S278 Snagging Items

PROJECT
Land East of Highgate Hill
Hawkhurst

DRAWING TITLE
A229 Highgate Hill
Site Access Design
General Arrangement

PJA JOB No. SUB-CODE
04609 - A - 0100 - A2
Revision Letter : P - Prelim / A - Approval / T - Tender / C - Construction

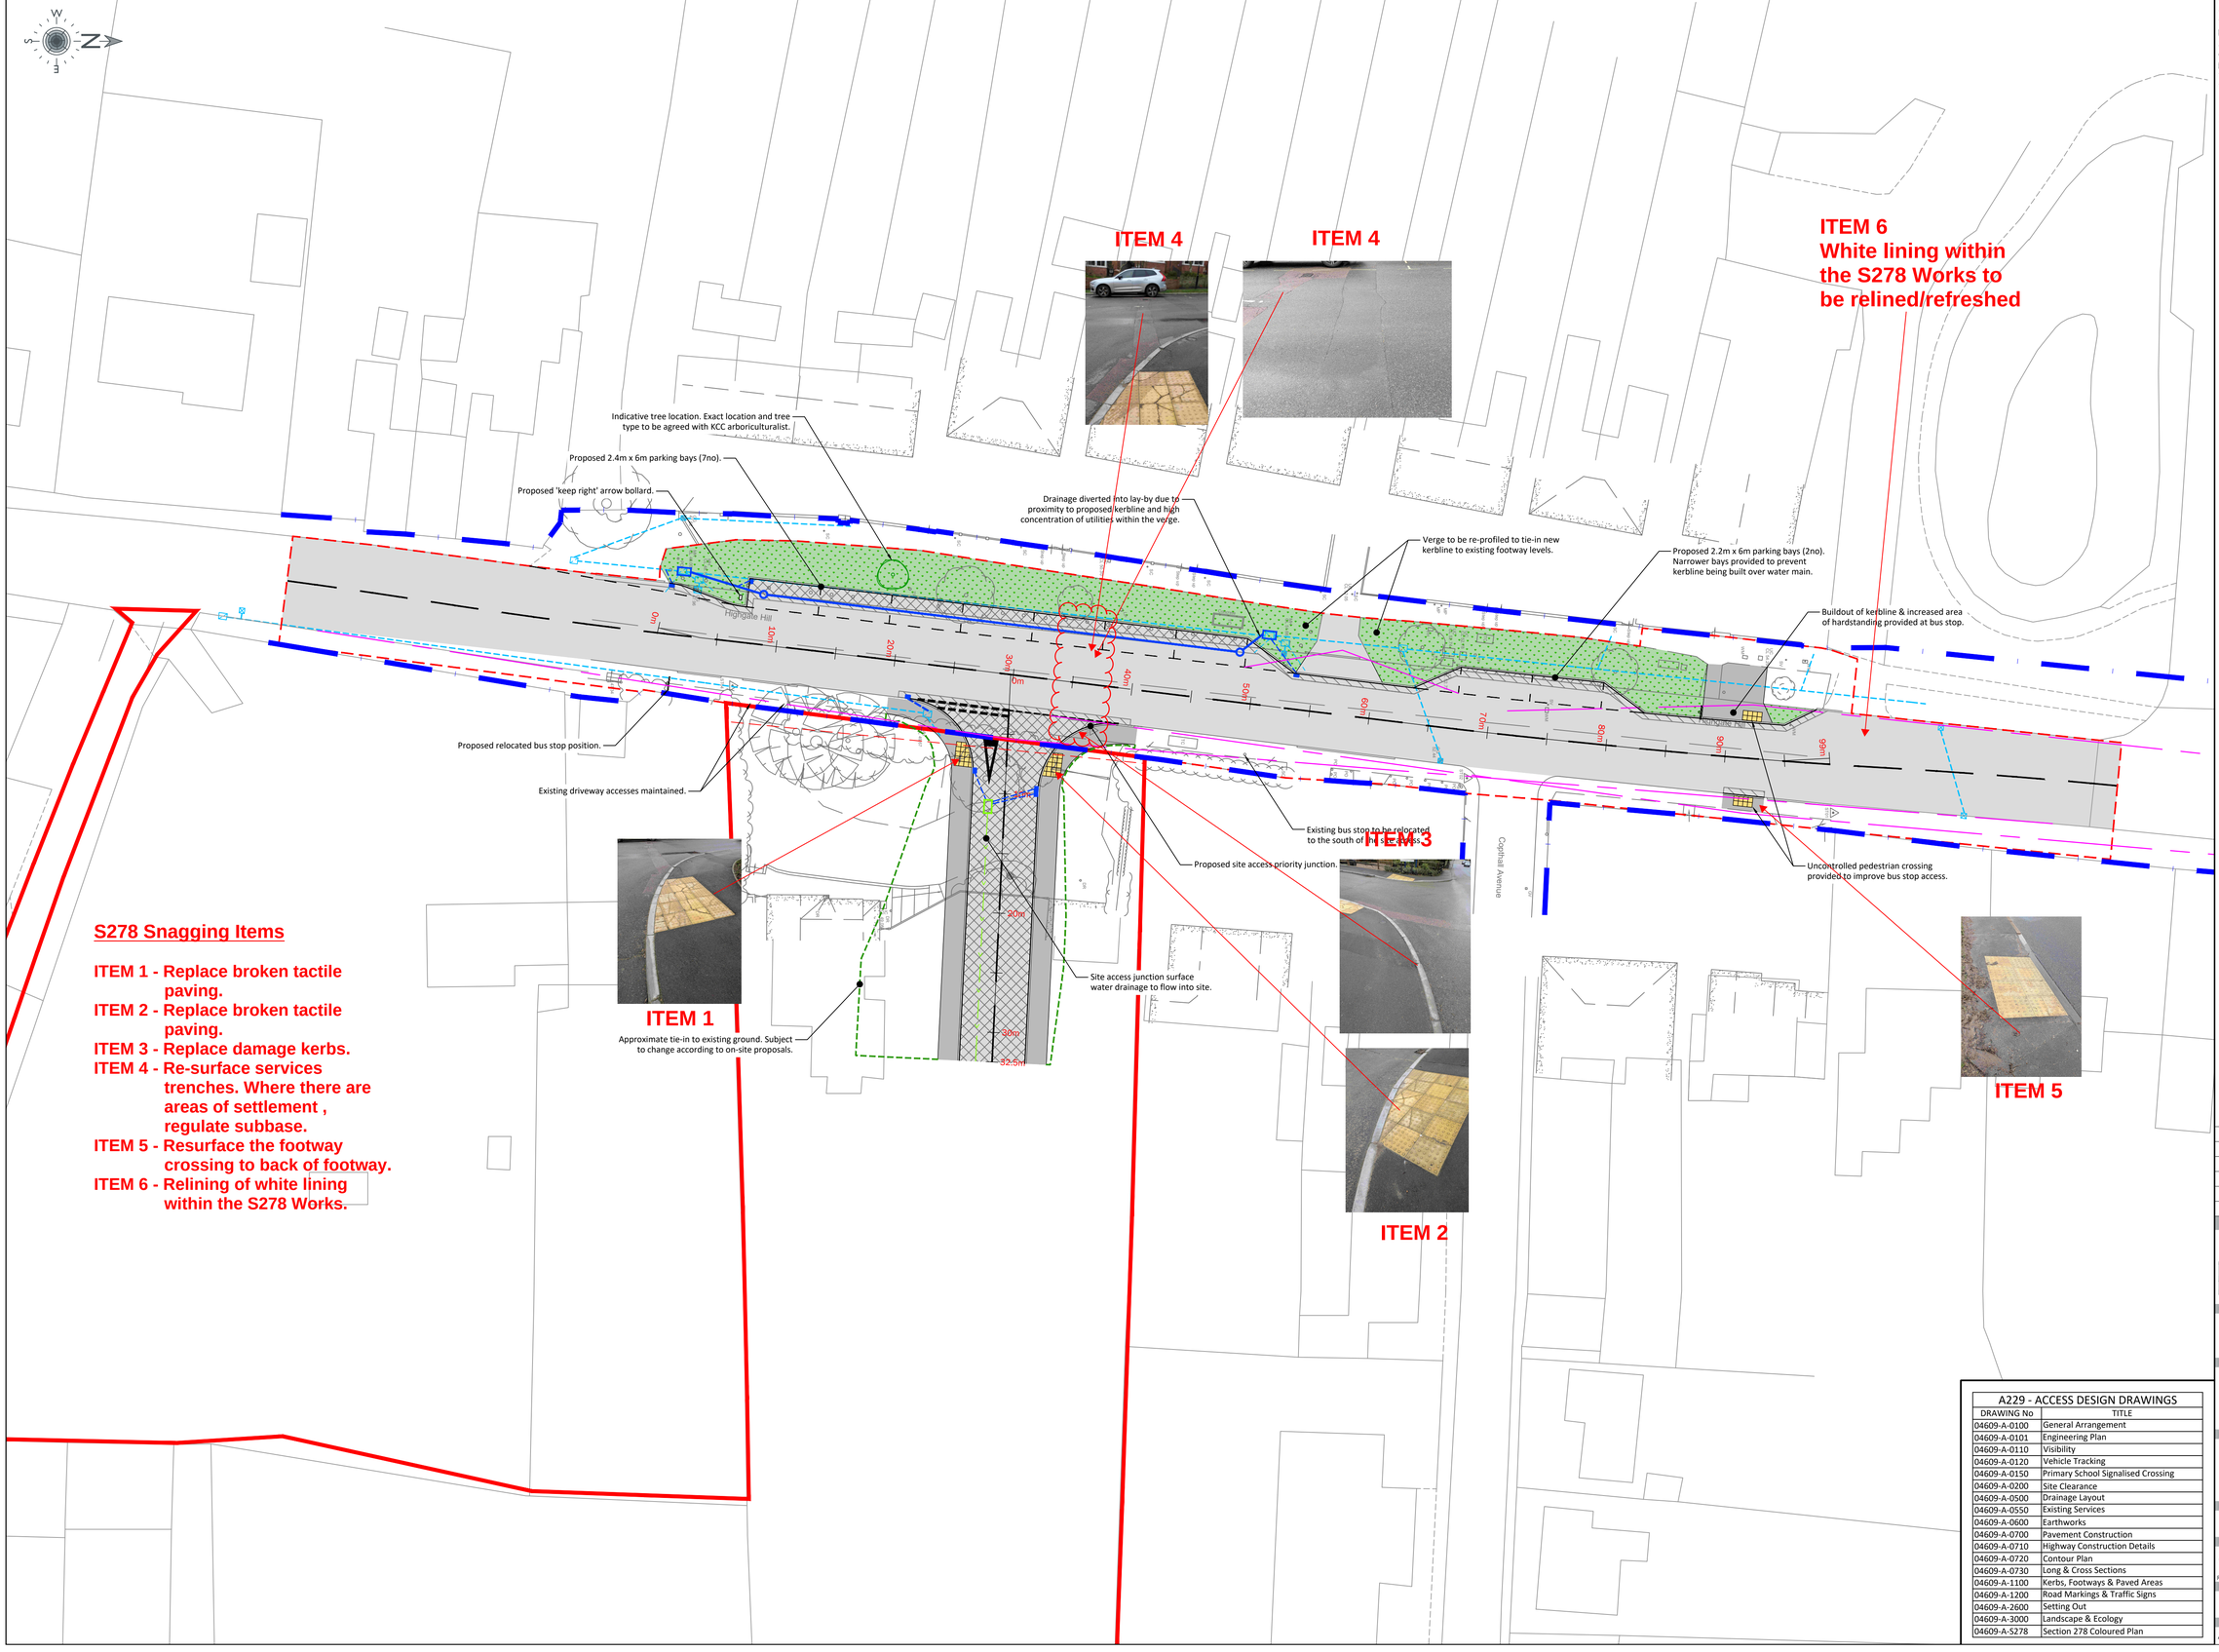
ITEM 1 - Replace broken tactile paving.
ITEM 2 - Replace broken tactile paving.
ITEM 3 - Replace damage kerbs.
ITEM 4 - Re-surface services trenches. Where there are areas of settlement , regulate subbase.
ITEM 5 - Resurface the footway crossing to back of footway.
ITEM 6 - Relining of white lining within the S278 Works.
